**RE: Response to Comments**  
**Crawford Station Former MGP Site – SSWP, Addendum 3, Revision 0, Group IV Parcels**  
The Peoples Gas Light and Coke Company  
**CERCLA Docket No. V-W-08-C-917**  
**CERCLIS ID – ILN000510192**

**RE:** Response to USEPA Comments  
Site-Specific Work Plan, Addendum 3, Revision 0, Group IV Parcels  
Crawford Station Former MGP Site, Chicago, Illinois  
The Peoples Gas Light and Coke Company

Y:\GIS\Projects\2016\2066\MXD\SSWPI\Group\_IV\Figure 6D\_SB\_Locs\_and\_Observations.mxd Author: tcushman Date/Time: 3/3/2016, 2:09:27 PM

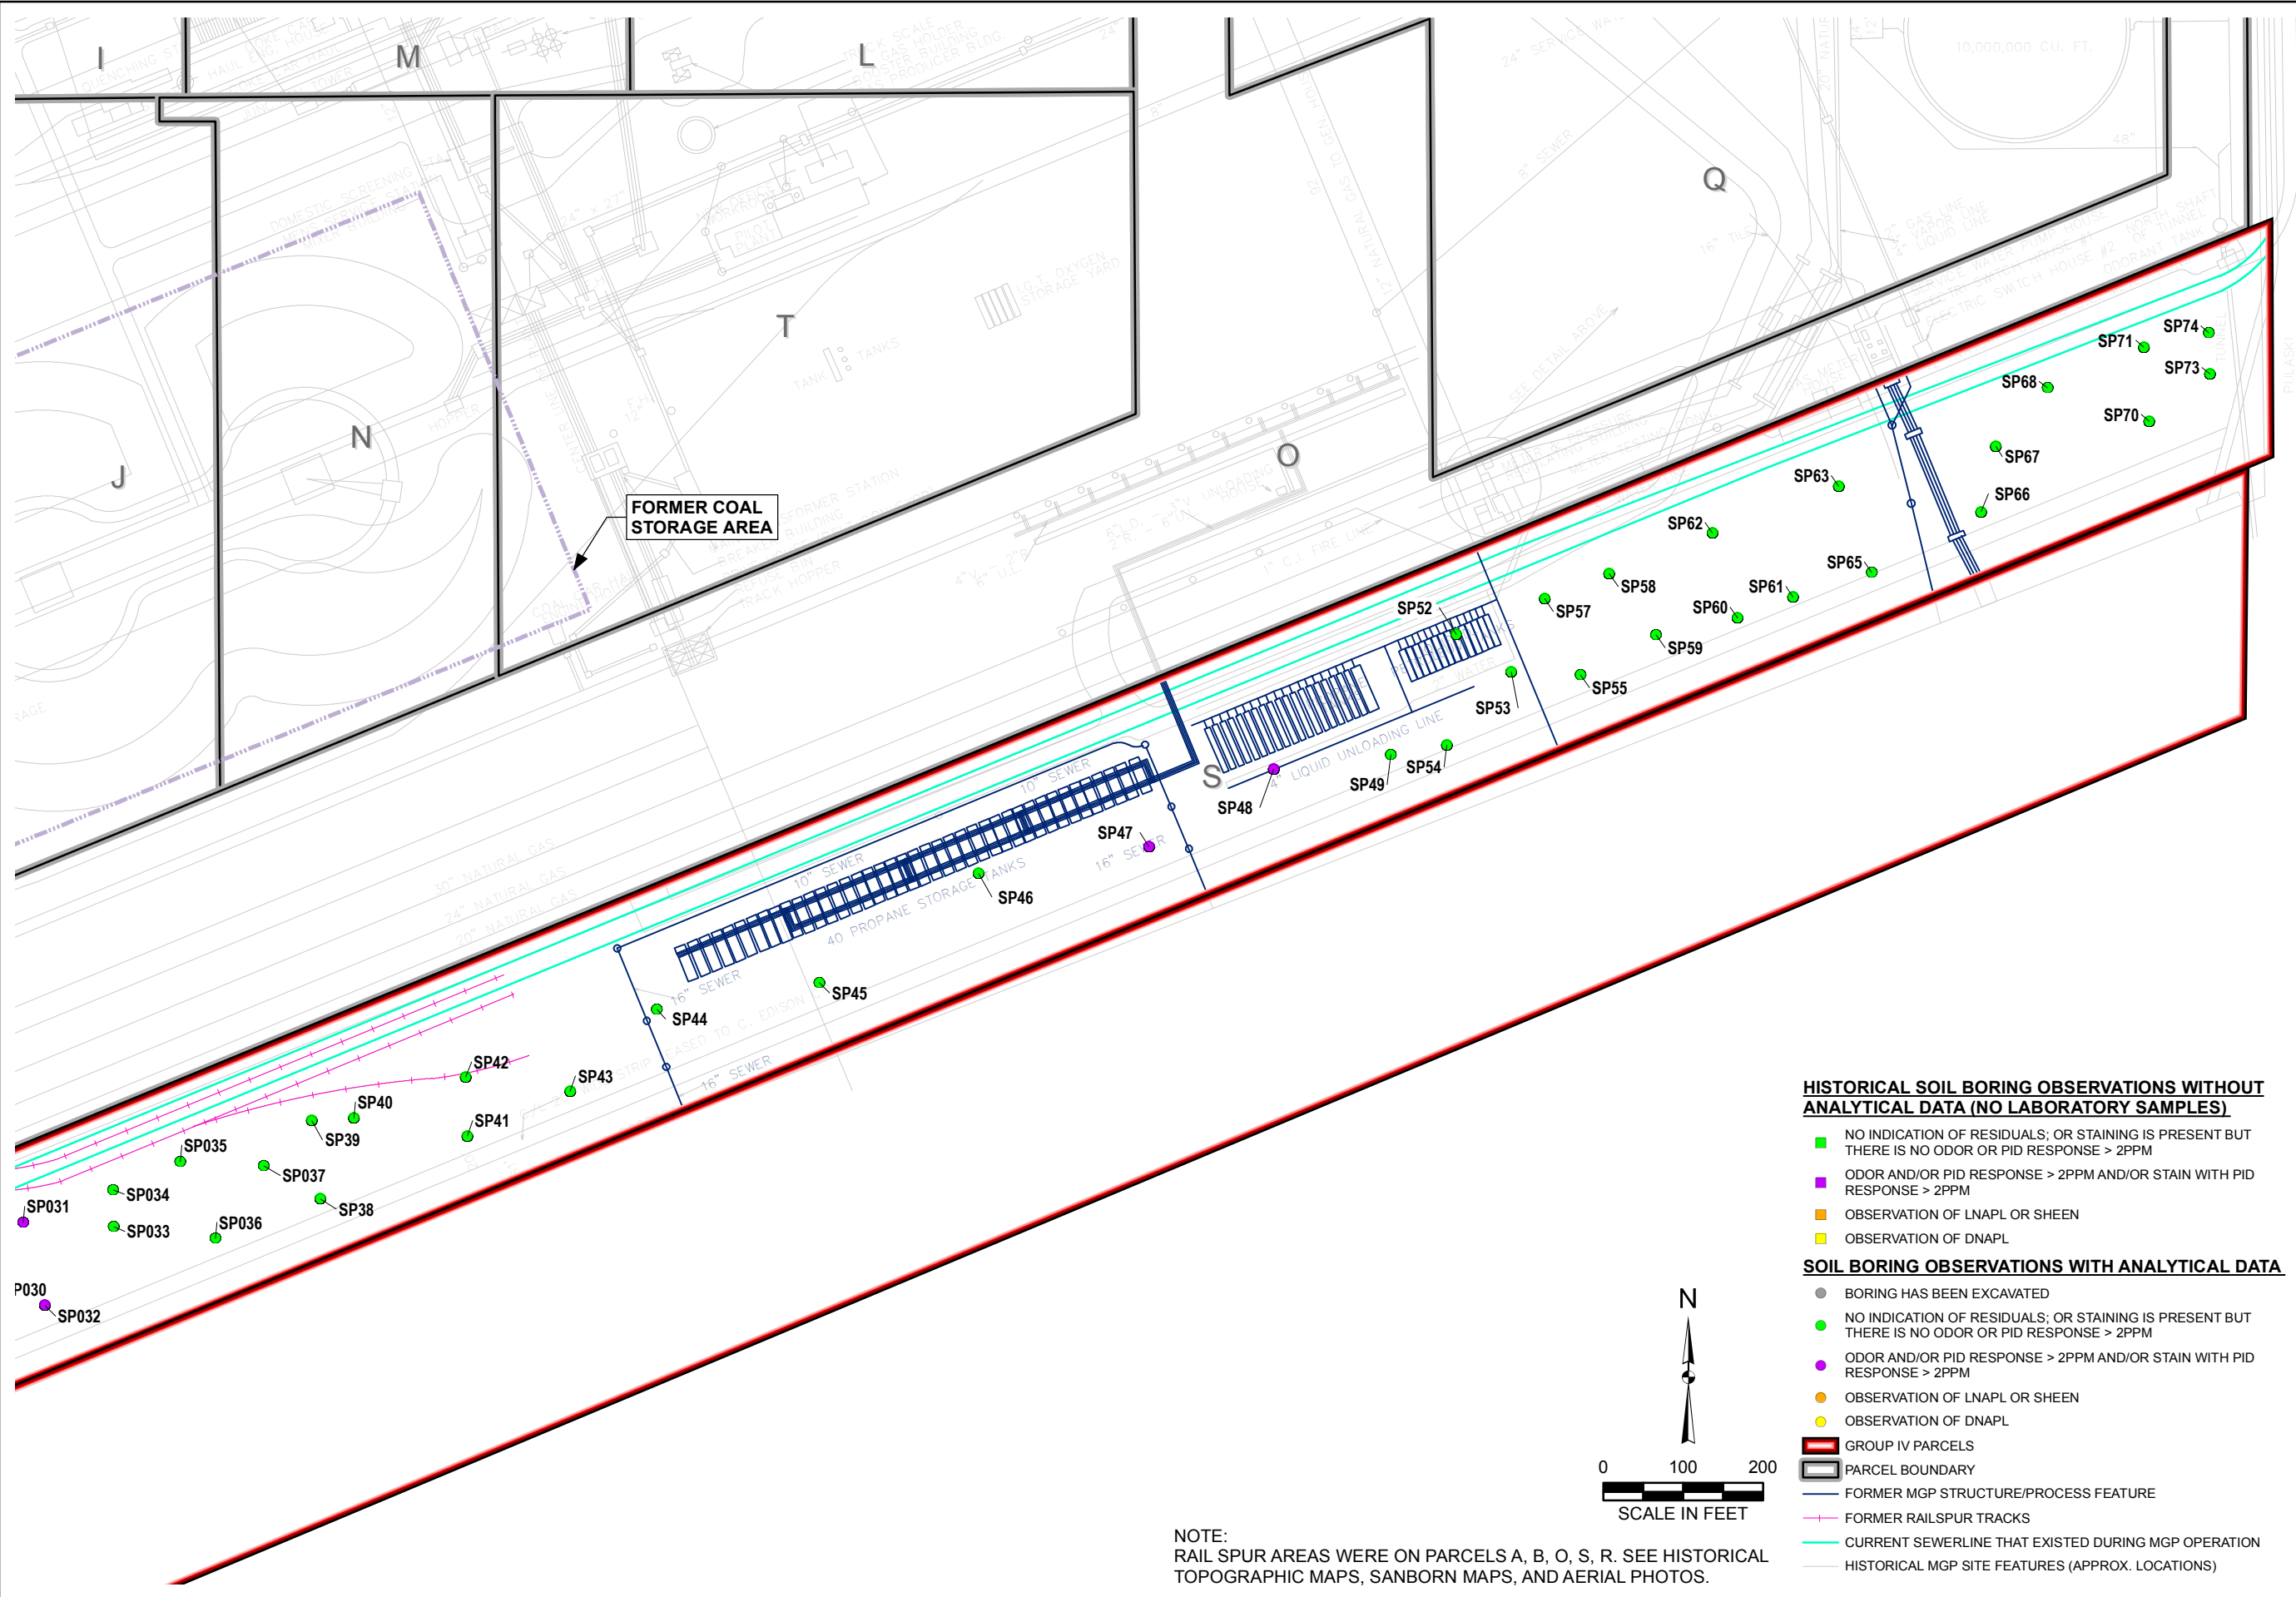
- 1.a. *Section 3.2.1.1 is entitled Rail Spur Area, but this Rail Spur area is not shown/designated on any map. The inclusion of all of the Parcel S data in this Section is confusing because there does not appear to be a rail spur on Parcel S, and it is not obvious where a spur was located in the past. Please clarify the text and figures so it is clear what areas are described in the sections of 3.2.*

**Response to SC 1b:** Section 3.2.1 is organized into two sections (former Rail Spur Areas in Section 3.2.1.1 and former Coal Storage Area in Section 3.2.1.2) for reasons described above. For additional specificity, Section 3.2.1.1 is further divided into four areas where former MGP residuals have been observed. Those four areas are Parcel S and three major areas of Parcels A, B, O (the ABO RAA, the Former West Fork Channel Area, and the North Central Area). These four areas are shown on Figures 6A-6D.

A fifth area, the Former Machine, Carpenter, and Paint Shop Area has been added to figures 6A and 6B. These features, though previously discussed through the text of the other areas, are now combine as one area. As discussed in Section 3.2.1.1, MGP residuals have not been observed in the borings near these features. These features and boring observations around these features are presented on Figure 6B and text has been added to Section 3.2.1.1 to highlight the lack of observations of residuals at these features.

FIGURE NO. 15

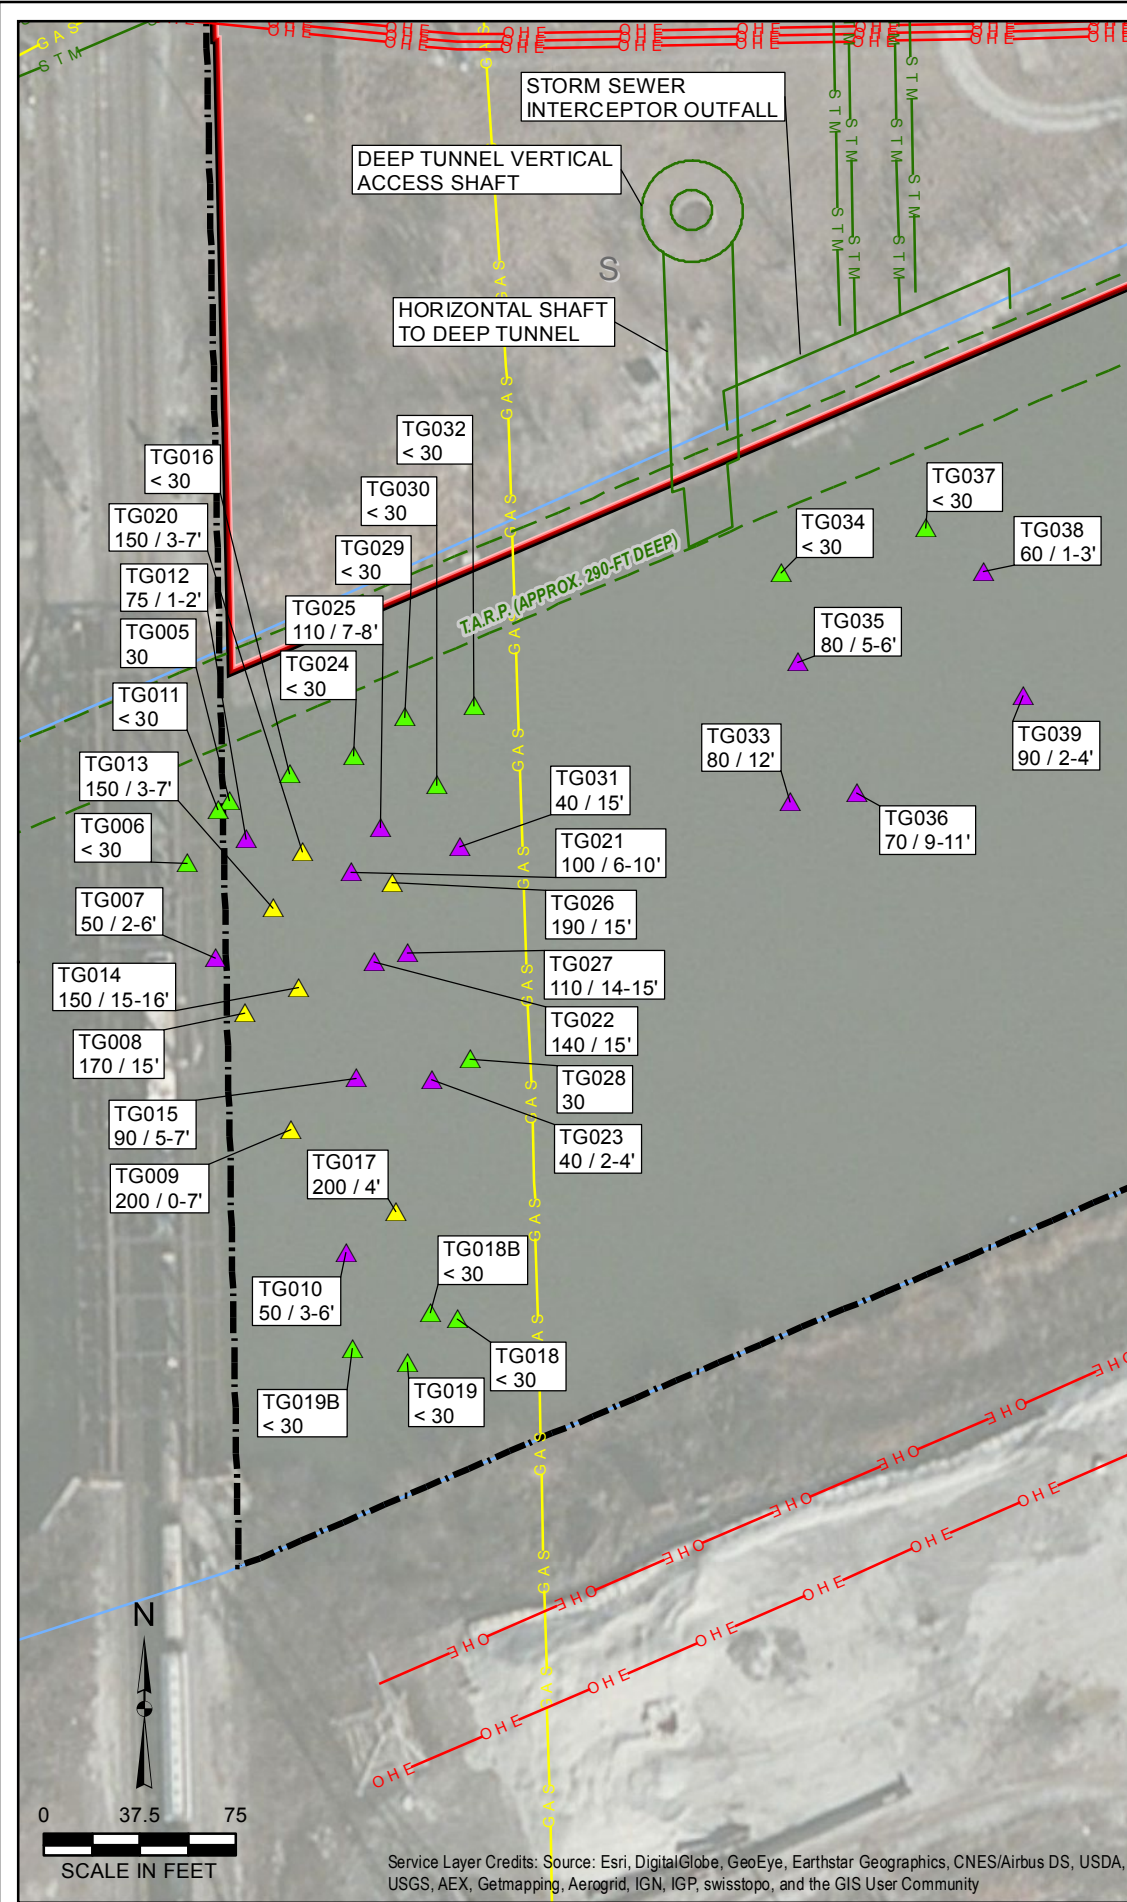
17. **Figure 15:** *Please identify the circular structure with a corridor extending into the river (left side of figure). Is this a historic MGP feature that may be associated with a discharge to the river? Please also specify from the historical records whether the storm sewers shown on the figure near the circular structure were present during MGP operations. Lastly, please identify the structure extending into the river on the right side of the figure. Is this a historic MGP feature that may be associated with a discharge to the river?*

**Response to SC 17:** The circular structure on the left side of the figure is a deep tunnel (Tunnel and Reservoir Plan) vertical access shaft. The vertical shaft drops to a horizontal shaft that connects with the deep tunnel buried at approximately 290 feet bgs. The deep tunnel was not in existence when the MGP was in operation. The structure on the right side of the figure is a former water intake and pump house for the MGP. These details have been added to Figure 15. The large outfall at the left side of the figure, the Kostner Street Outfall, was installed between 1938 and 1940; the MGP operated until 1954. According to PGL documents, lateral drains from the MGP property were tied into the Kostner Street Outfall. Additional information regarding these features has been added to Section 4.5.

FIGURE NO. 18

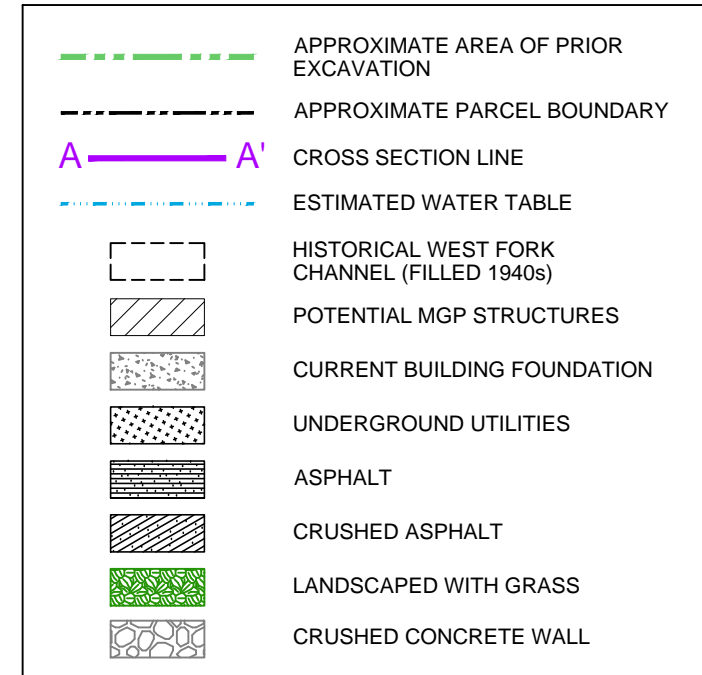
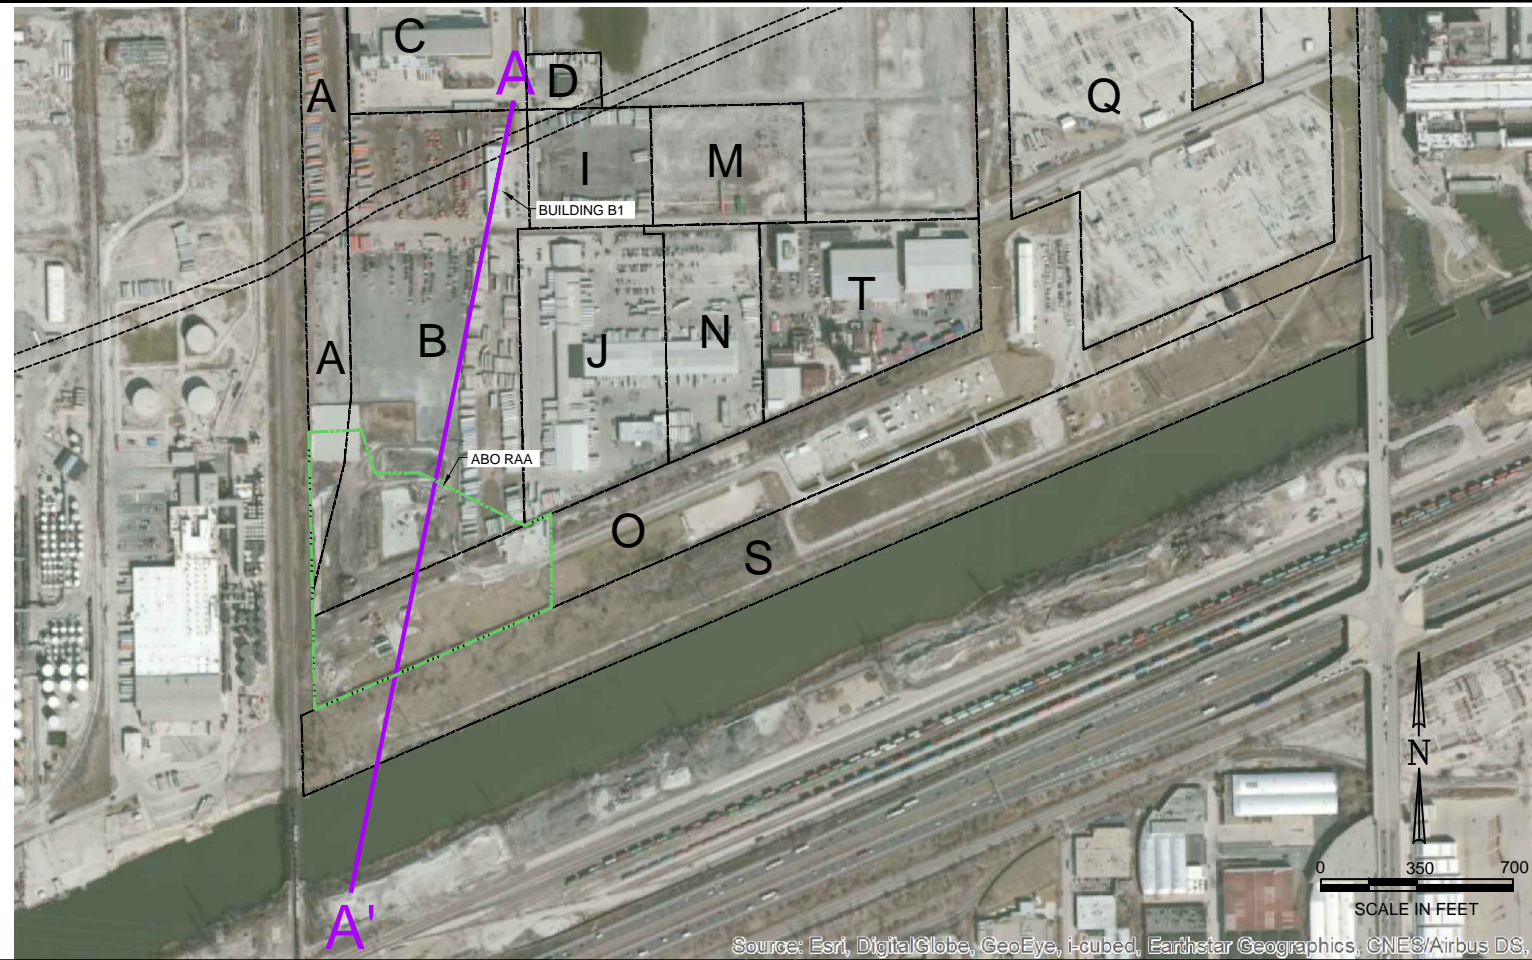
21. **Figure 18** – the inhalation pathway for visitor/trespasser/recreator should be shown as potentially complete.

**Response to SC 21:** While the outdoor inhalation pathway for the visitor/trespasser/recreator is potentially complete, the effect of dilution by wind on airborne contaminants bound to particulates or chemical vapors released at the ground surface would render it an insignificant exposure pathway for this receptor. This has been clarified in the text of the SSWP, Addendum 3, Rev 1, Section 4 (Site-Specific Conceptual Site Model Summary). In addition, the definition of the open circle symbol for Figure 18, Site-Specific Conceptual Site Model, has been modified to read:
